Hydrol. Earth Syst. Sci. Discuss., author comment AC1
<https://doi.org/10.5194/hess-2021-5-AC1>, 2021
© Author(s) 2021. This work is distributed under
the Creative Commons Attribution 4.0 License.

Reply on RC1

Author comment on "Drought-induced non-stationarity in the rainfall-runoff relationship invalidates the role of control catchment at the Red Hill paired-catchment experimental site" by Yunfan Zhang et al., Hydrol. Earth Syst. Sci. Discuss.,
<https://doi.org/10.5194/hess-2021-5-AC1>, 2021

Response to Reviewer #1

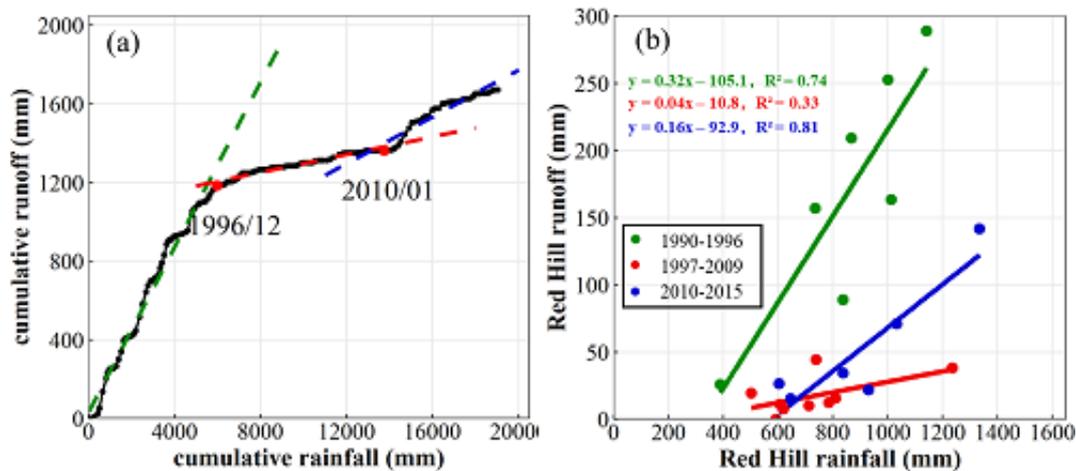
- It's a flaw that the manuscript lacked detection of changes in the rainfall-runoff relationship for the treated catchment. Although it's obvious why there is a control and a treated catchment, I think it's important to apply the appropriate parts of the applied analysis for the treated catchment, also to have a better understanding of the underlying processes; to confirm or to deny the non-linear behaviour of the treated catchment.

A. If the treated catchment has not been reforested, did you expect the treated catchment to show similar behaviour as the control catchment?

B. Does the treated catchment already shows the same non-linearity as the control catchment?

A. If the treated catchment has not been reforested, we expect the treated catchment to show similar behaviour as the control catchment. Because the terrain, meteorology, area of the two catchments are very similar, when the treated catchment is not reforested, the land cover types of the two catchments are also similar, both are grassland. When prolonged drought occurs, the change of hydrological process in two catchments should be similar.

B. Yes, the treated catchment shows the similar non-linearity as the control catchment, as shown in Figure R1 and Figure 5 (Page 39). But observed changes in treated catchment should be driven by two factors, i.e. afforestation and prolonged drought by assuming prolonged drought can lead to changes in rainfall-runoff relationship of the treated catchment.

Figure R2 The variation in monthly rainfall of the Kileys Run catchment (control catchment), New South Wales, Australia, during the periods of 1990–2015.

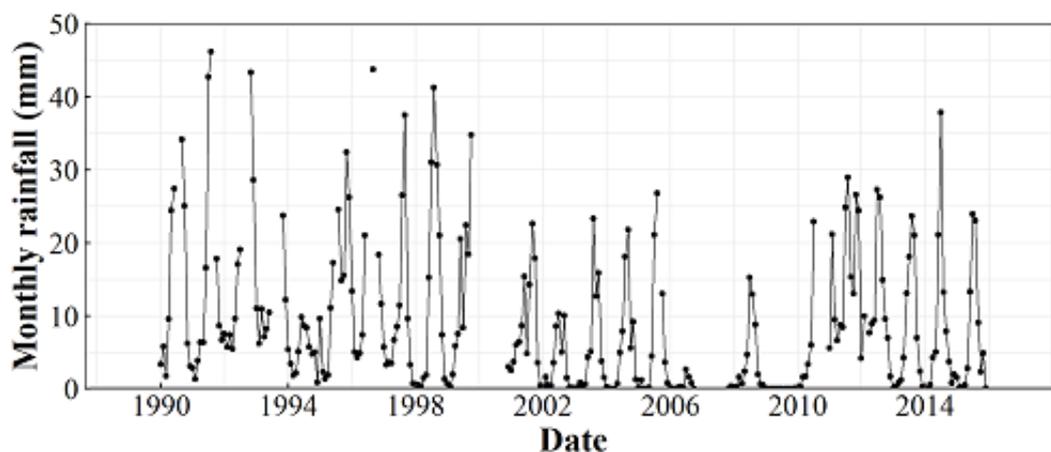
- Lines 139-147; what is the variation in monthly rainfall? Seasonal? What Köppen climate?

The variation in monthly rainfall can be seen in Figure R2. Seasonal changes in monthly rainfall can be seen in Figure R3. The monthly rainfall decreased great during the period of 2001-2009 and increased after 2010, but is still less than the monthly rainfall before 2001. There is more precipitation in winter (June, July and August), but the difference amongst rainfall of four seasons is small. The climate type in Kileys Run and Red Hill catchment is Cfb (temperate maritime climate) (Peel et al., 2007).

Figure R4. (a) Monthly runoff at control (Kileys Run) vs. treated (Red Hill) catchments in New South Wales, Australia, during the calibration period, and (b) Monthly rainfall vs. runoff of the treated catchment during the calibration period. Dashed line is the 1:1 line.

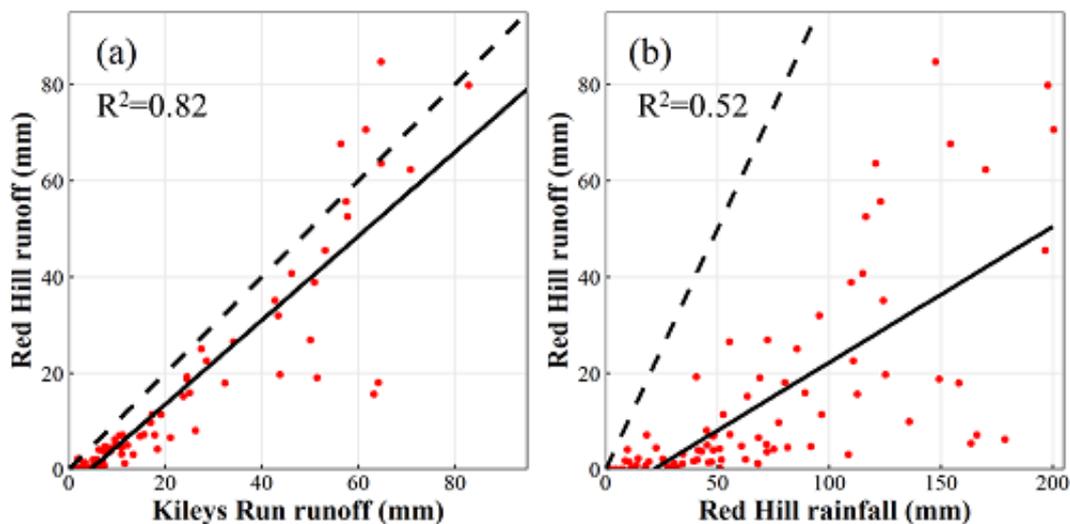
- Figure 4. A. The left figure is Kileys Run, but in the caption you mention Red Hill first, change either the caption or the figure order. B. The x- and y-axis do have different ranges, this makes the graphs difficult to compare and to understand the meaning of the results.

Reply: Thanks for your helpful suggestions. Figure 4 will be replaced by Figure R4 in revised manuscript as follows:

A. The title of Figure 4 has been changed to that of Figure R4.

B. The runoff-runoff relationship for the two paired catchments in Figure 4 (a) is used in the paired catchment method, and the rainfall-runoff relationship of the treated catchment in Figure 4 (b) is used in the time-trend analysis method.

Figure R5. Daily flow duration curves of the Kileys Run catchment (i.e., control catchment), New South Wales, Australia, over four different periods (see legend).

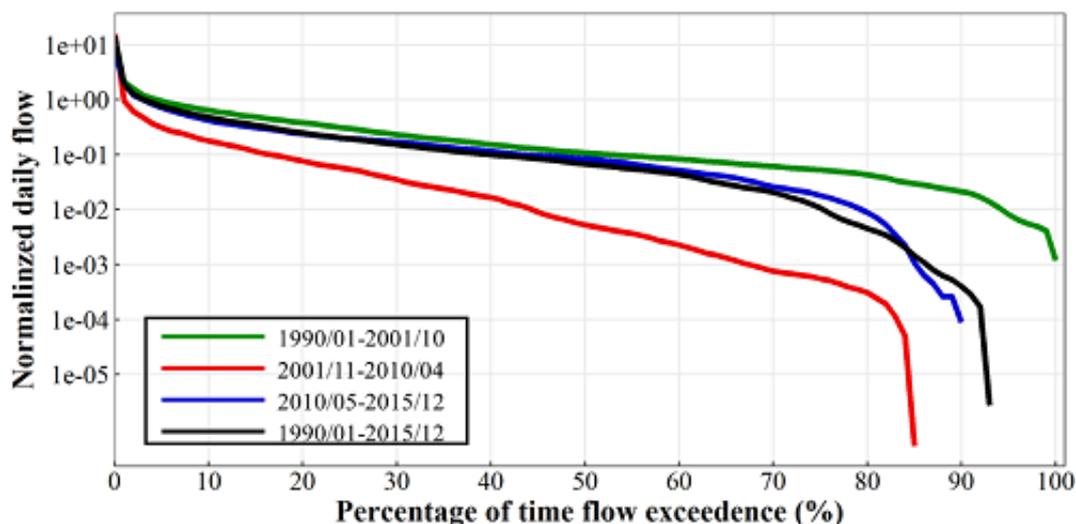
- Figure 6; you may consider add the daily flow duration curve for the entire measurement period (1990-2015) to indicate the differences;

Reply: Thanks for your helpful suggestions. The daily flow duration curve including the entire measurement period (1990-2015) can be seen in Figure R5.

The FDC of the entire measurement period (1990-2015) is close to the FDC of the third

period (2010-2015). There is 6% no-flow days during the whole period. In the first period (pre-drought), the second period (after drought) and the whole period (including the whole drought period), high flows have a highly consistent change, but the difference amongst low flows is significant. It indicates that the impact of prolonged drought on the low flow is more serious than that of the high flow. When the rainfall increases, the high flow may recover quickly, but the low flow may recover slowly.

Figure R6. Estimated monthly values of parameters (a) C and (b) SC used in the two-parameter monthly water balance model for the Kileys Run catchment (control catchment), New South Wales, Australia, during the period of 1990–2015.

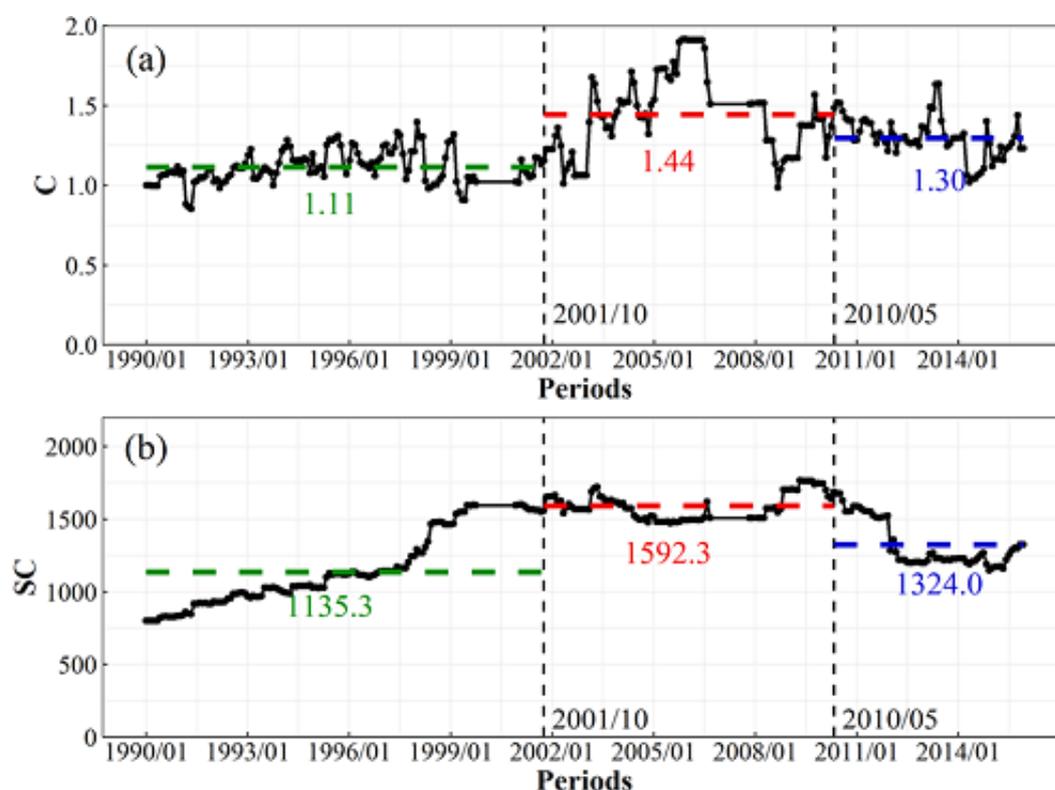
- Figure 7; The x-axis of the graphs could be better aligned;

Reply: Thanks for your helpful suggestions. Figure 7 will be replaced by Figure R6.
